**City of Sherwood
PLANNING COMMISSION
Sherwood City Hall
22560 SW Pine Street
Sherwood, OR 97140
November 24, 2009 – 7 PM**

a. Appeal of Hearing Officer Decision on SUB 09-01 – McFall Subdivision.

TO: Planning Commission
FROM: Julia Hajduk, Planning Manager
DATE: November 17, 2009
RE: Appeal of McFall Subdivision (SUB 09-01)

PRELIMINARY PLAN FOR McFALL SUBDIVISION

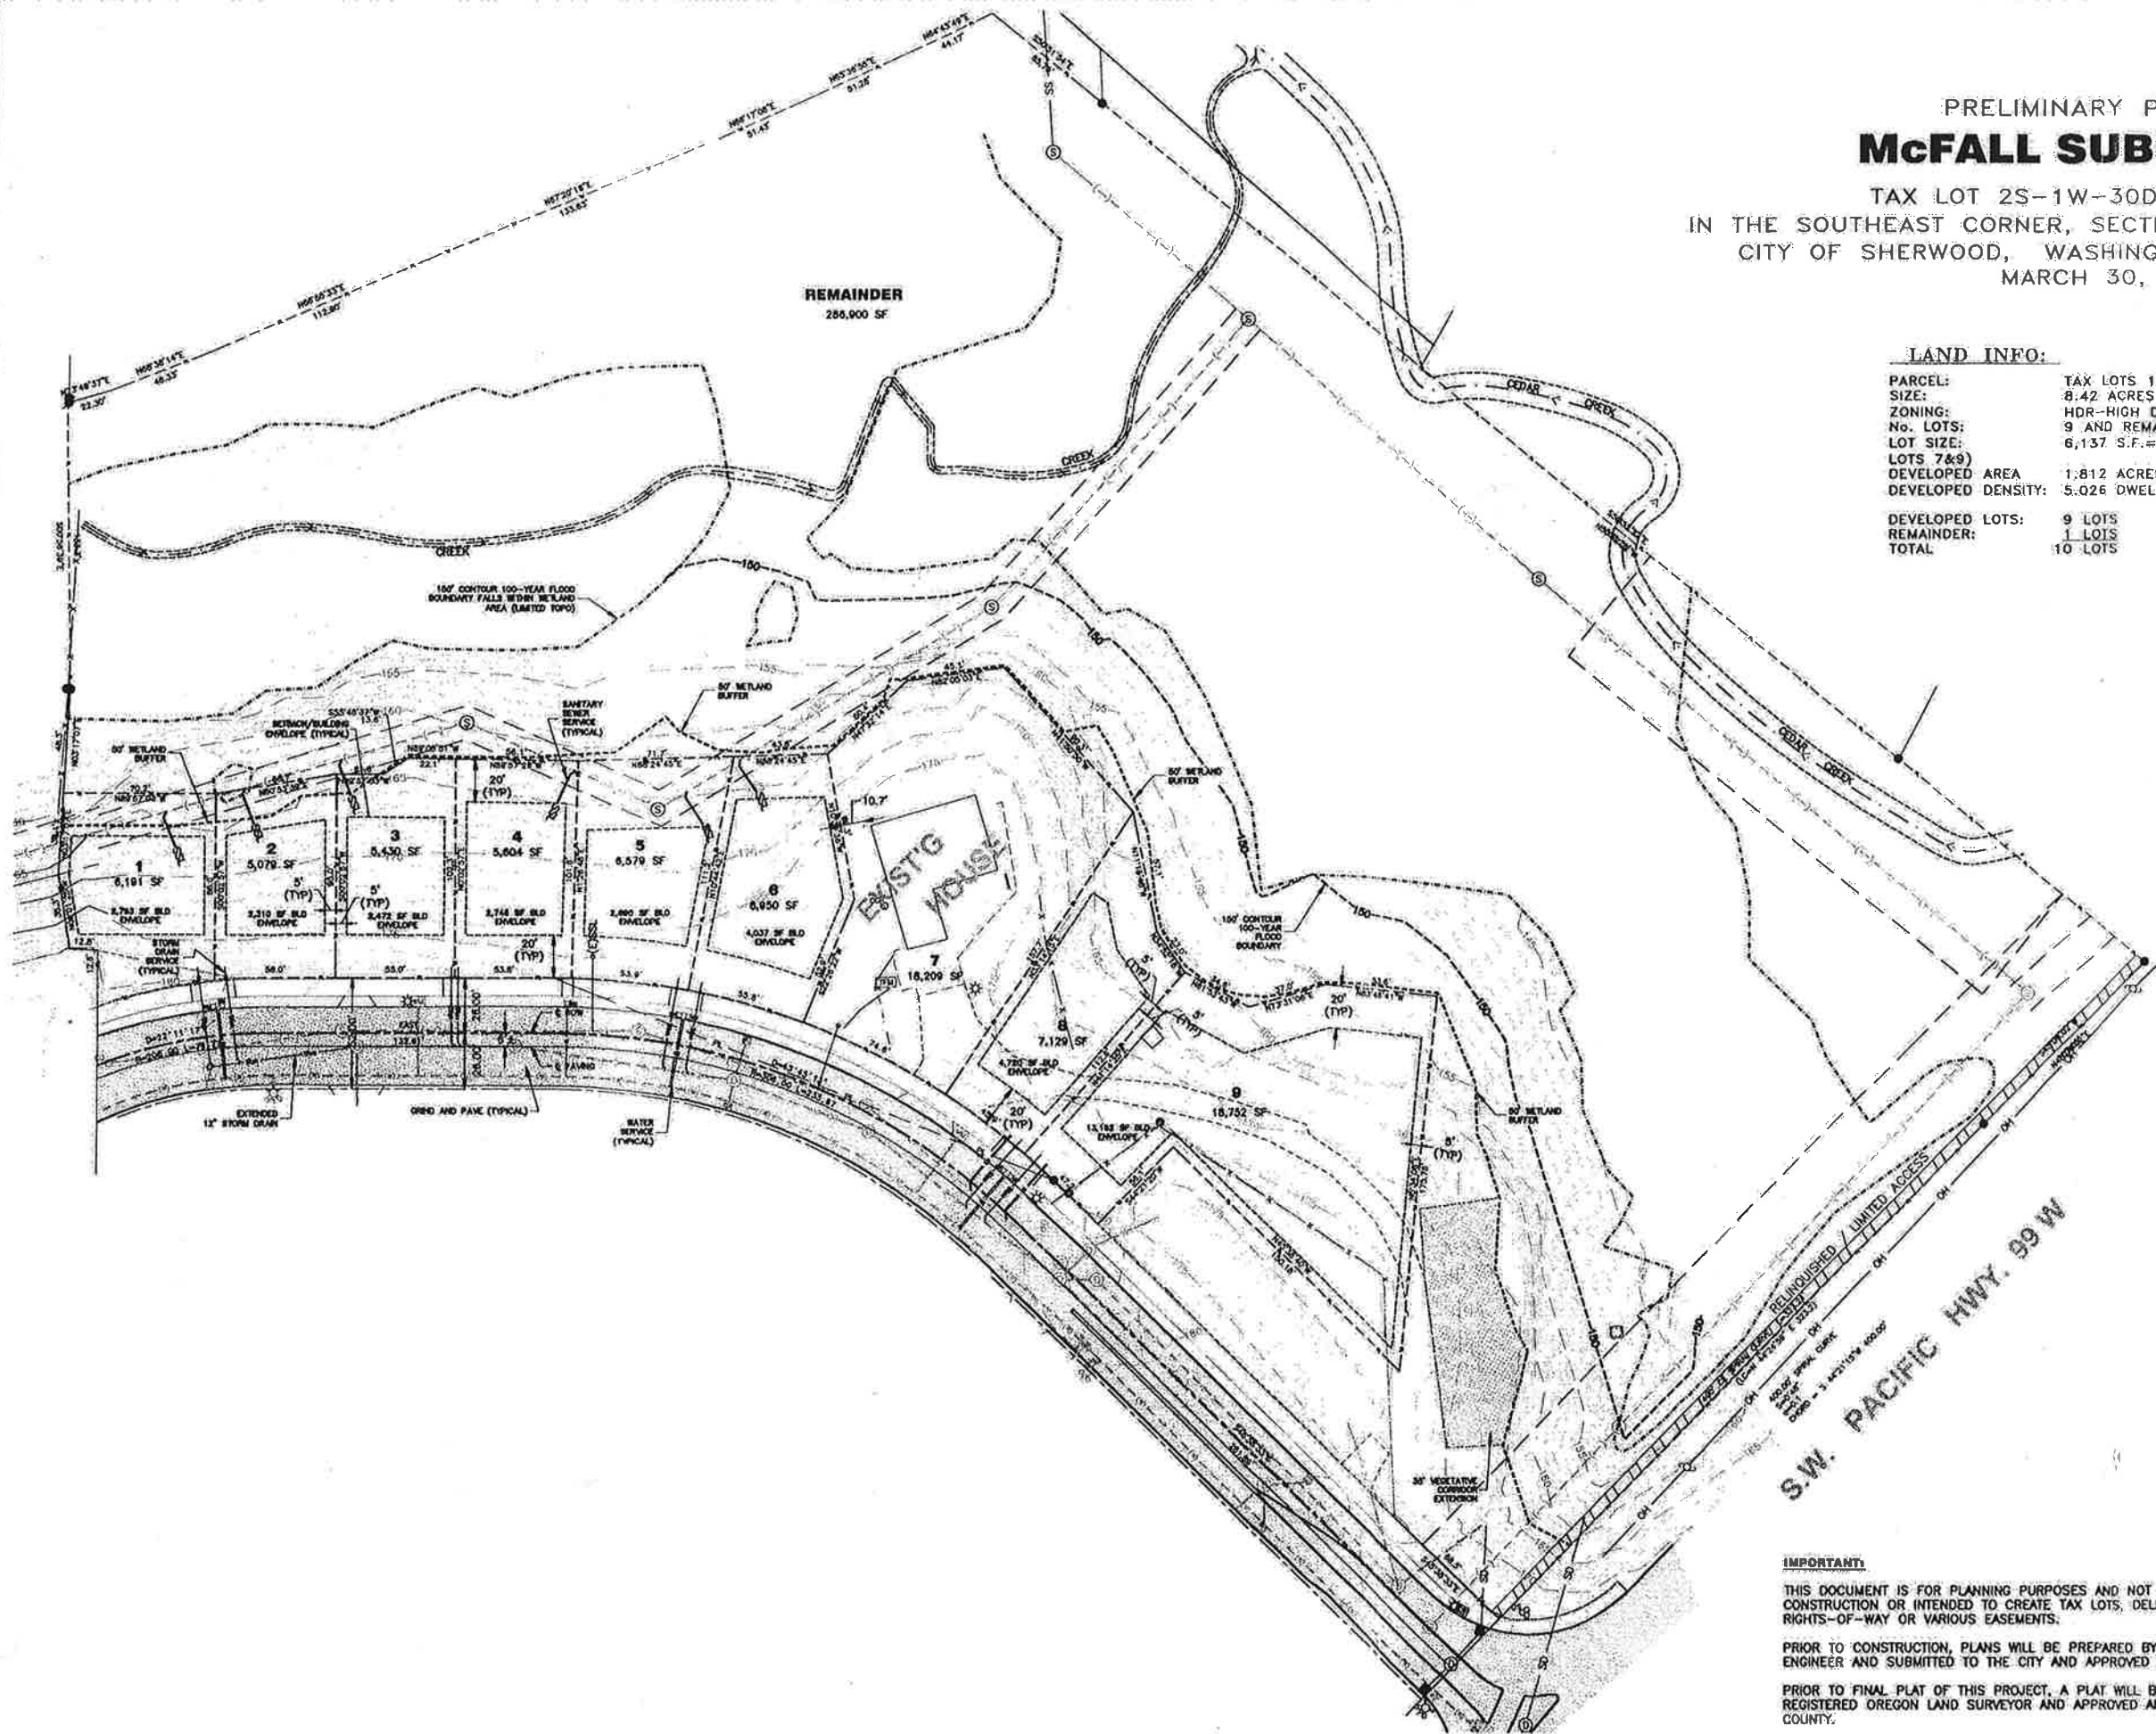
On October 27, 2009, the applicants appealed the Hearings Officer's decision. The appeal is based on language in the decision to the effect

that the “remainder lot” is undevelopable. The appeal states that the “conclusionary remarks about the remainder land prevents any contemplated gifting.”

The appellants assert that reference to the remainder lot as undevelopable are mistakes and requests that they be removed from the findings. It also appears that they object to a reference to the remainder lot being “dedicated” versus “gifted” because they believe this distinction limits the potential tax benefit of donating the property.

On Sheet 1 of 2 of the plans submitted, the summary information references the "net buildable area" and the "non-buildable area." The note on Sheet 2 of 2 references one undevelopable remainder lot.

Staff recommends that the Planning Commission consider the appellants arguments and the required findings. References to the conveyance as a dedication can be easily replaced with "donated, gifted or otherwise conveyed," or similar language the appellant believes will not limit the tax benefits of a donation. However, because most, if not all, of the remainder lot is undevelopable for the purpose of constructing residential structures, modifications to the text should not be changed. The applicant's narrative and plans indicate the remainder lot is undevelopable and the findings and conditions of approval would have been markedly different if the applicant indicated that the remainder lot was developable.
